SLOVENSKI STANDARD
SIST EN 60794-1-21:2015/A1:2020

Optical fibre cables - Part 1-21: Generic specification - Basic optical cable test procedures - Mechanical tests methods (IEC 60794-1-21:2015/A1:2020)

AMENDMENT 1
AMENDEMENT 1

Optical fibre cables –
Part 1-21: Generic specification – Basic optical cable test procedures – Mechanical test methods

Figure 34 – Indoor installation simulation apparatus

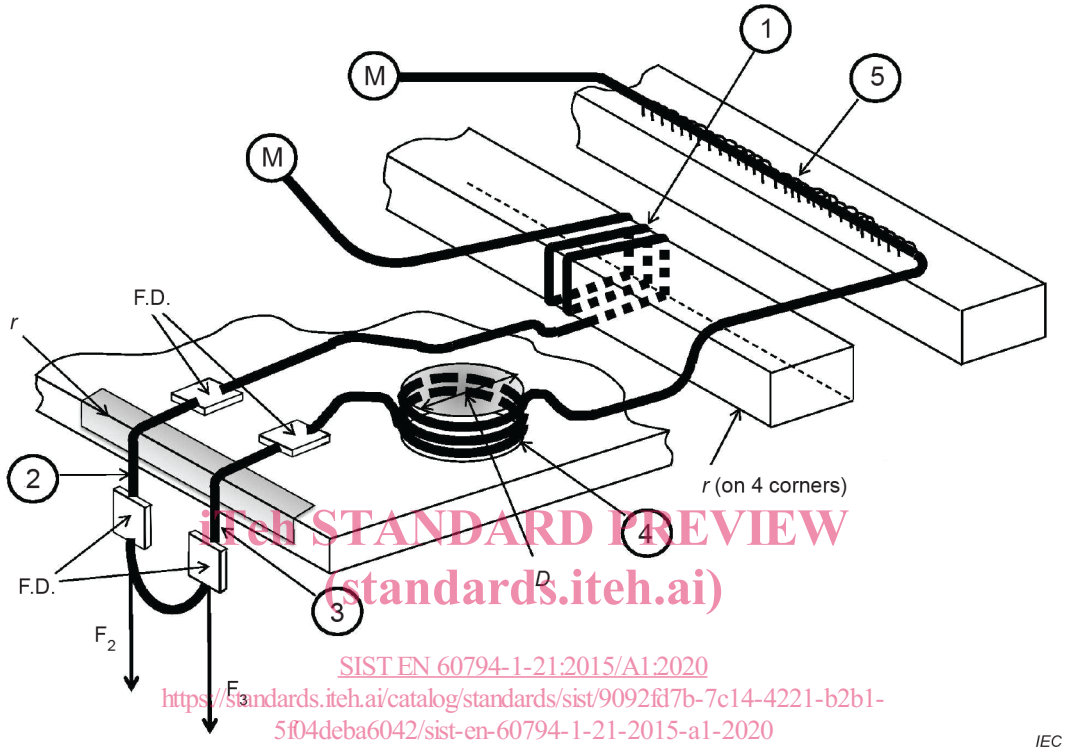
32 Method E27: Indoor simulated installation test

Replace the existing text by the following new text:

A continuous length of cable shall progress through each of the following conditions. See Figure 34.

1) Fourteen or fifteen 90° corner bends (1 mm radius), as appropriate for the fixture, with minimal manual tension, sufficient to wrap the cable around the fixture.

2) One 90° corner bend (1 mm radius) with a 2 kg load.
3) One 90° corner bend (1 mm radius) with rated residual load.
4) Two 10 mm diameter mandrel wraps.
5) Thirty attachment points, as specified in the detail specification.

Figure 36 – Stapling and bending test fixture

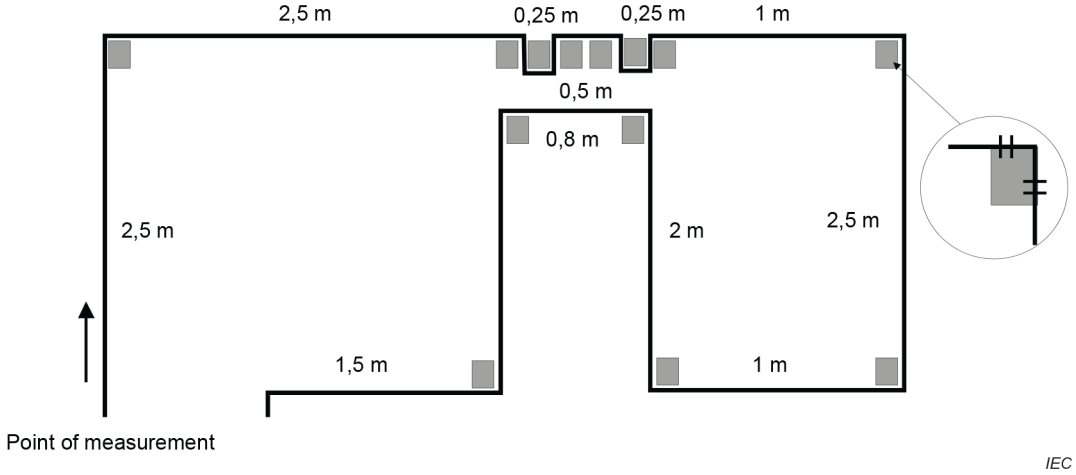
The apparatus of Figure 36 may be used for the multiple corner bends section (1) and the serial attachment section (5) of Figure 34 with results that are comparable.
